寄件者: Tang Lok San [REDACTED]
寄件日期: 2026年04月27日星期一 14:35
收件者: tpbpd/PLAND
副本: Andrea Wing Yin YAN/PLAND
主旨: Re: S. 16 Planning Application No. A/YL-KTN/1167 - Departmental Comments
附件: AYL-KTN 1167 20260427.pdf

臨時貨倉 (危險品倉庫除外)
連附屬設施及相關填土工程(為期3年)

3 cases comments on 23-3-2026

Title: Drainage Proposal - LAYOUT	D01
Drawn by: DM	Date: 23-4-2026
Check by: DM	Scale: ---

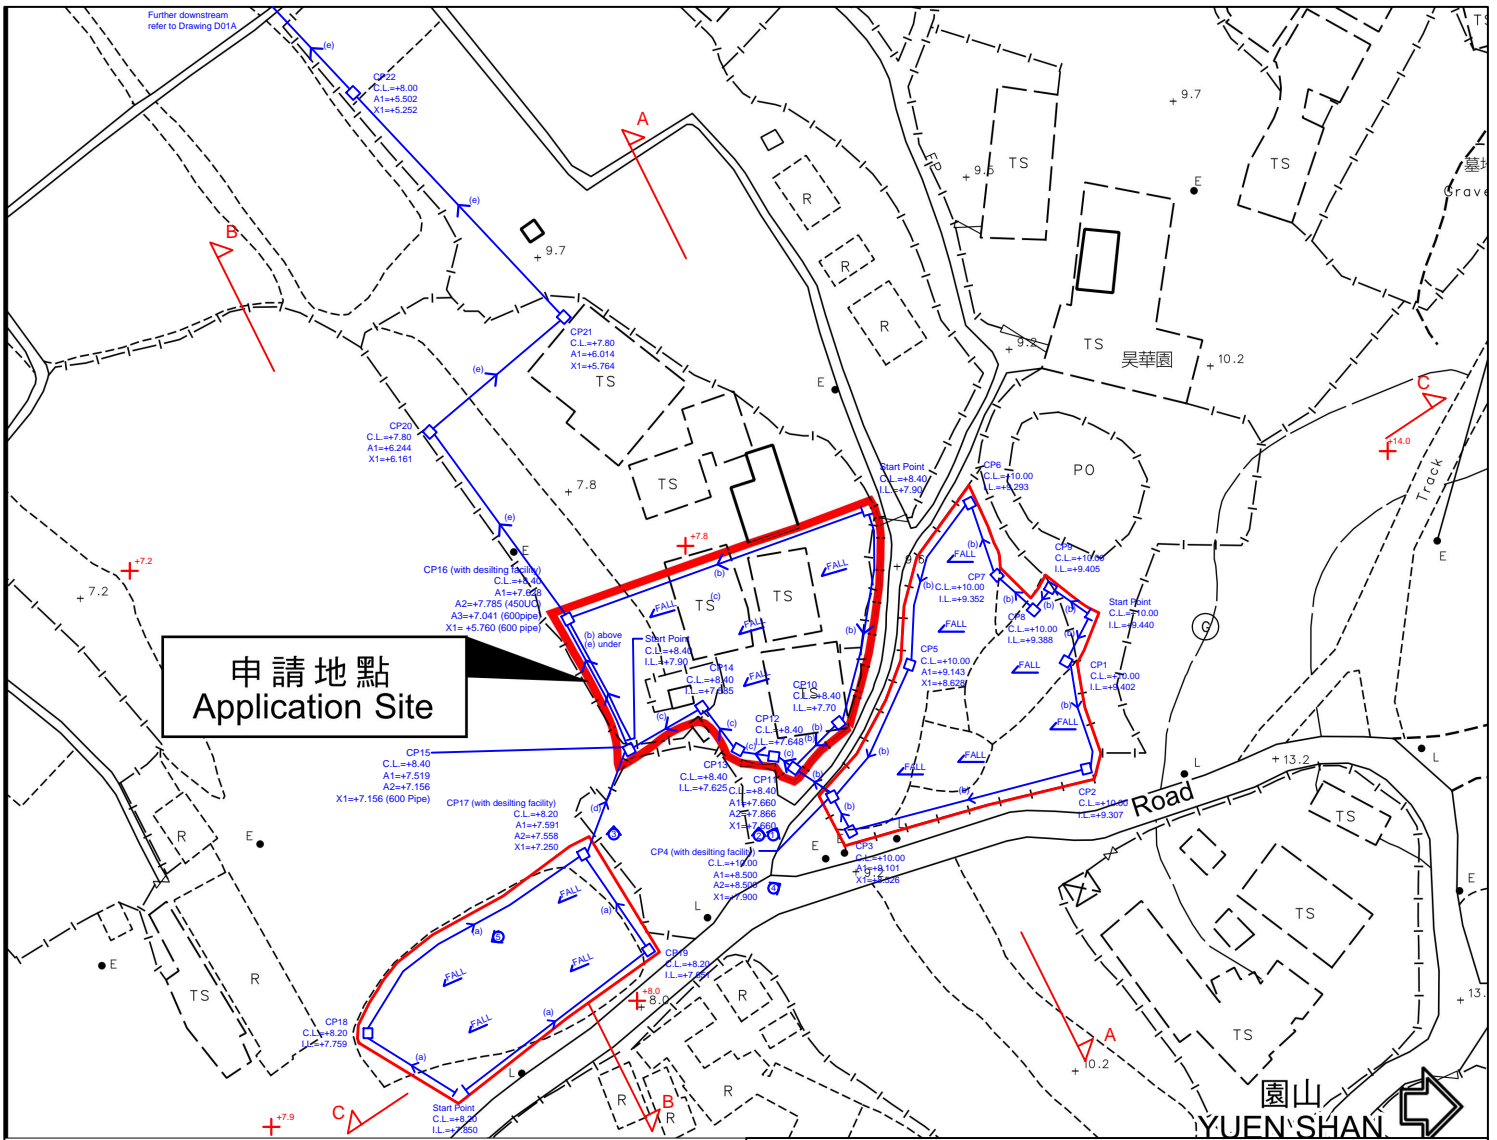
7. The applicant should clarify design assumption (H), i.e. average slope from the summit of the catchment to the point under consideration, adopted in the hydraulic calculation.

H value is revised.

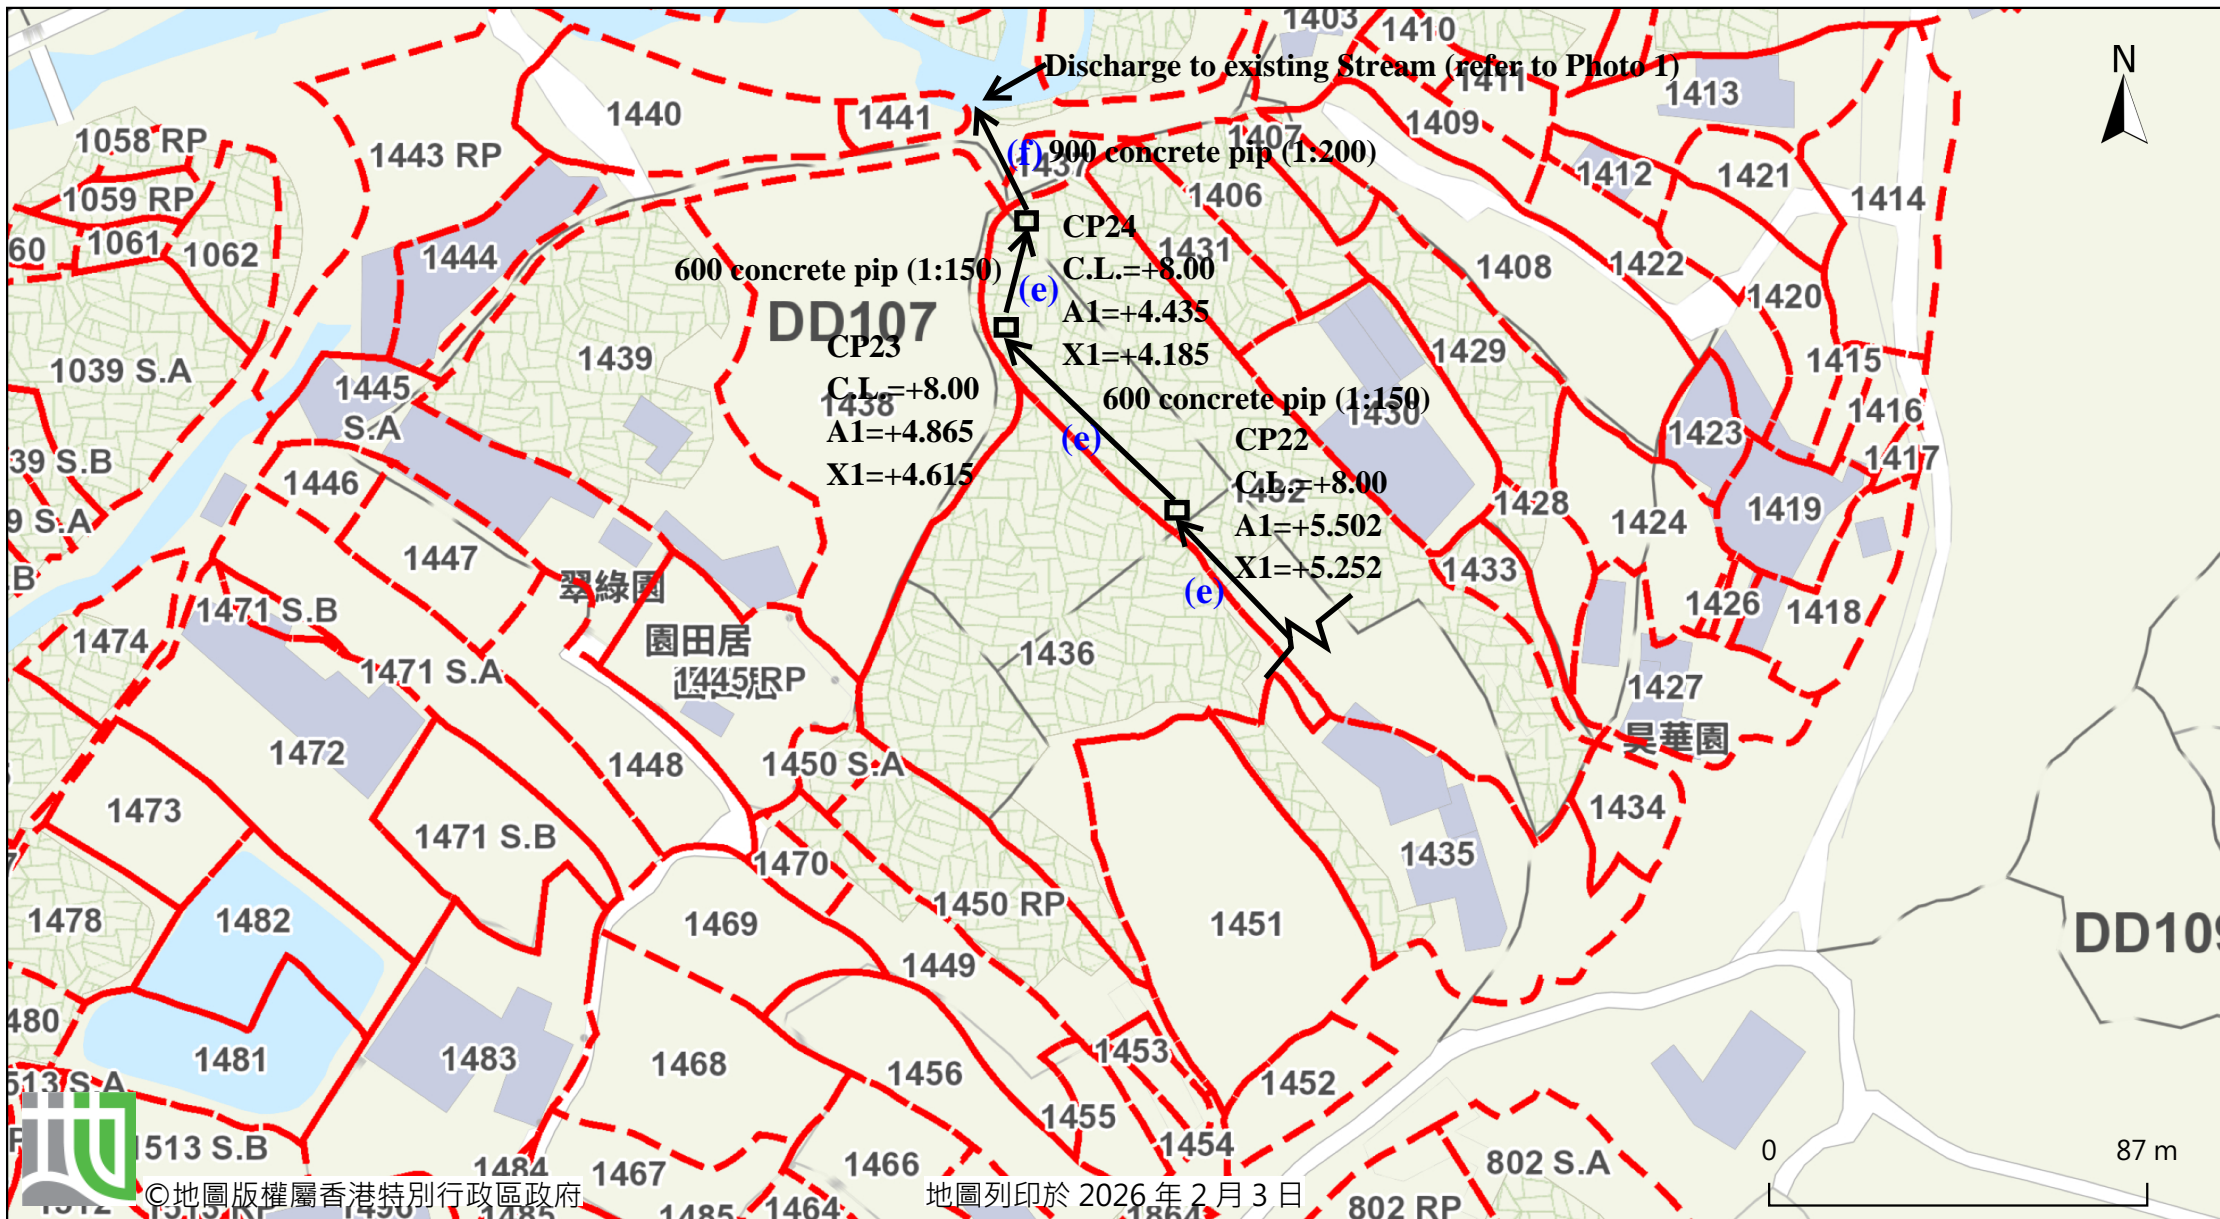
1. Drawings (No.: D01 & D01a): The applicant should clarify discrepancy of size of the proposed stormwater drainage pipe at the downstream of catchpit CP24 mentioned in the proposal.

2. The applicant should clarify discrepancy of gradient of the proposed drainage facilities shown in drawing (No.: D01) and the submitted hydraulic calculation. Also, the applicant should clarify discrepancy of surface runoff 'Q3' shown in the submitted hydraulic calculation and chart.

3. Drawing (No.: D01): The proposed 900 mm dia. stormwater drainage pipe is missing on the submitted drainage plan.

It is revised accordingly.

It is revised accordingly.

It is revised accordingly.

Catchment Area Plan

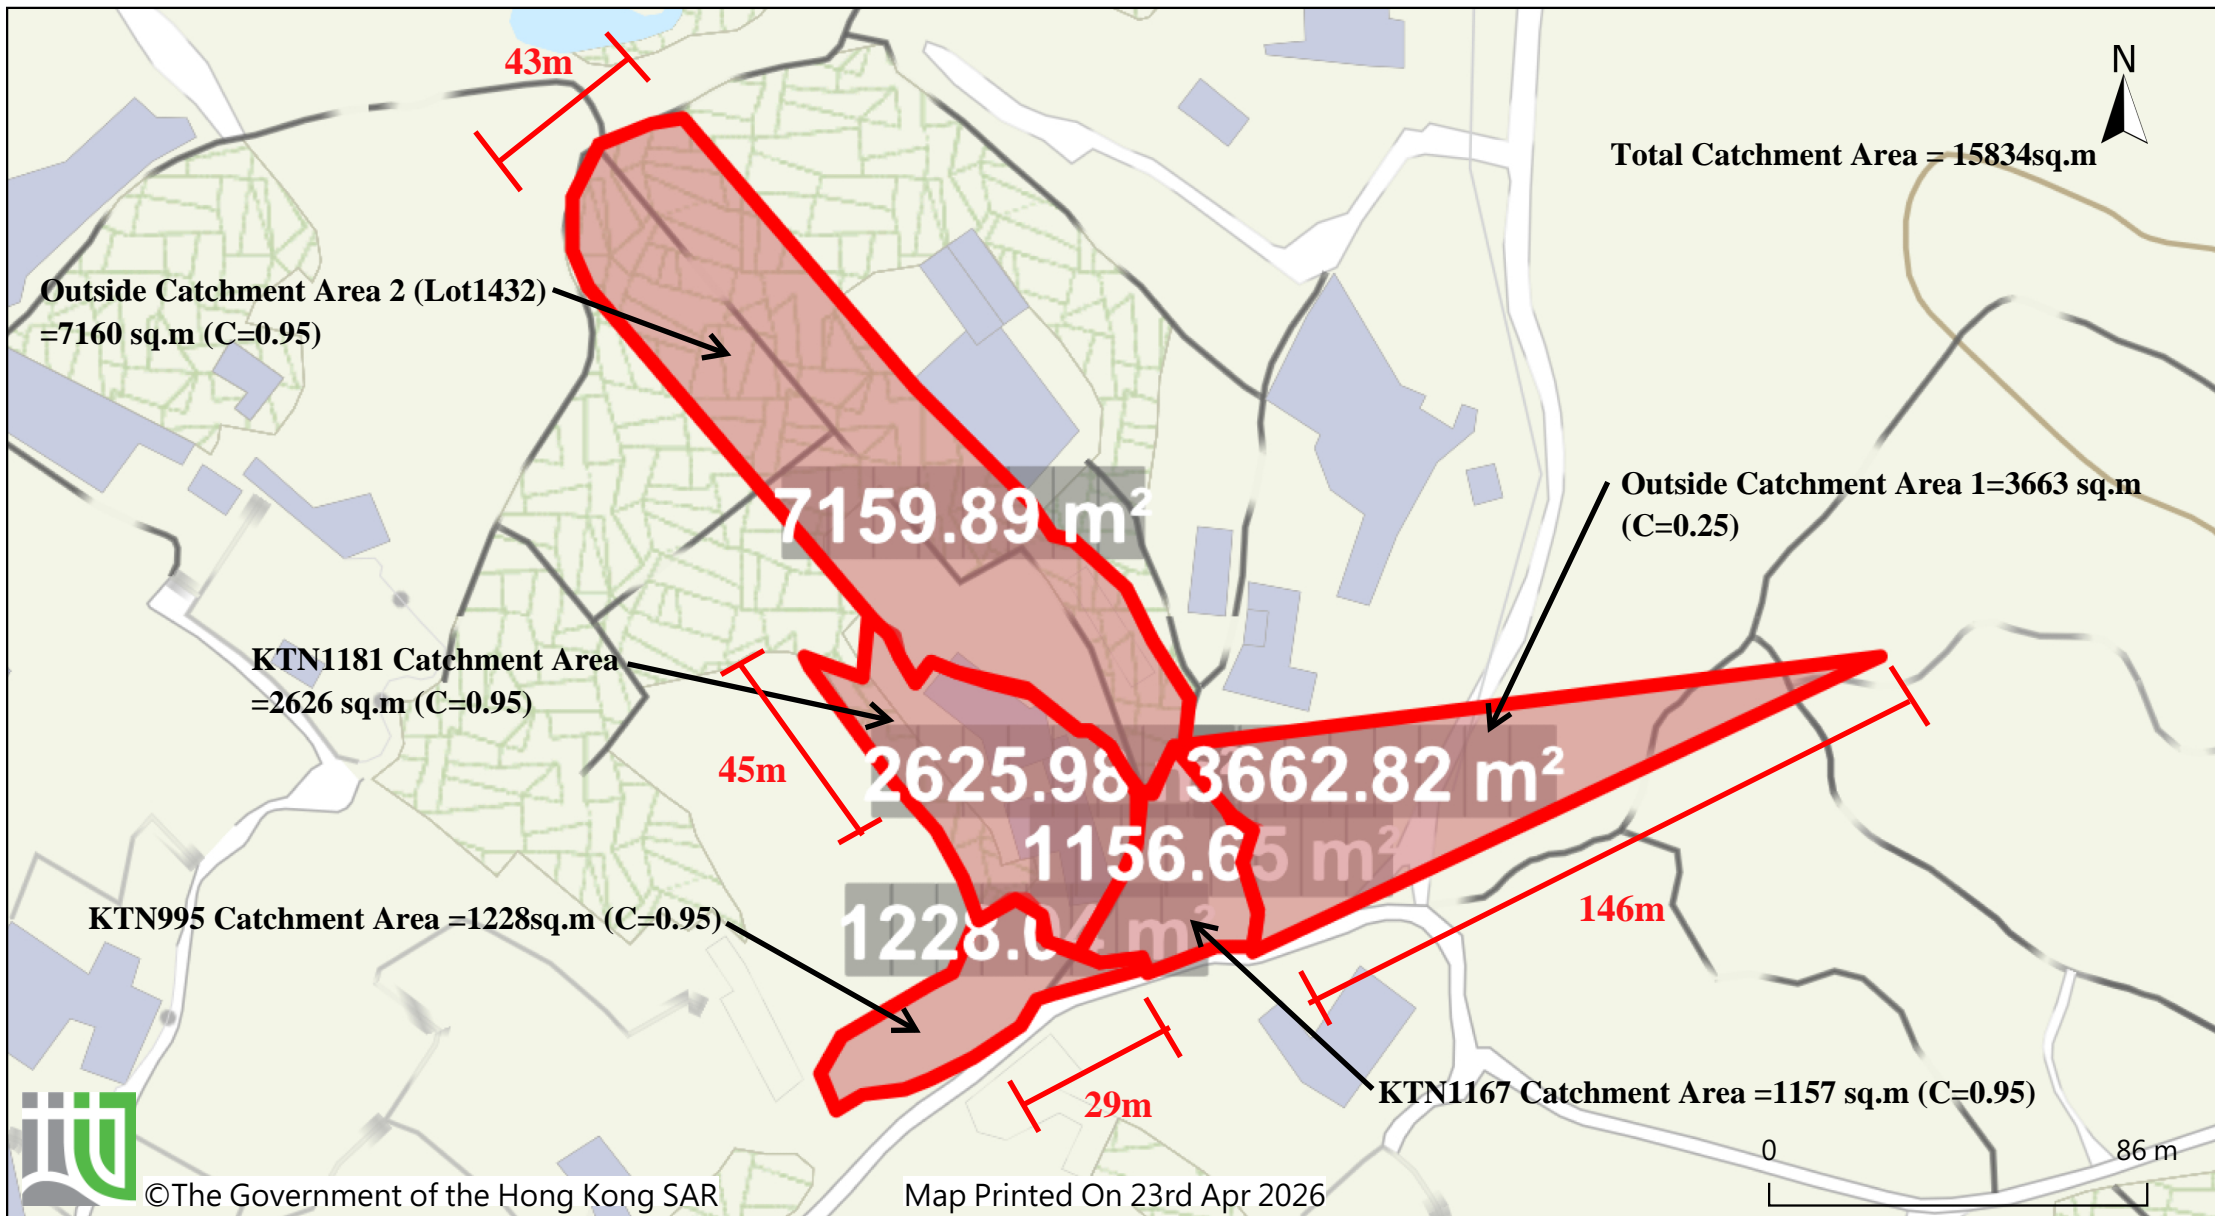
5. According to the topography, catchment area of site under another planning application (No.: A/YL-KTN/995) is underestimated. Also, the applicant should clarify why external catchment area of site under another planning application (No.: A/YL-KTN/1181) is 2661 m². Besides, the applicant should evidence to support adoption of 6938 m² as external catchment area of site under another planning application (No.: A/YL-KTN/1181) and demonstrate with hydraulic calculation that the proposed 600 mm dia. stormwater pipe (at the downstream of the proposed catchpit CP16) are adequate to collect, convey and discharge the surface runoff accrued on the application site and the overland flow intercepted from the adjacent lands.

The catchment area plan is revised and hence the calculation.
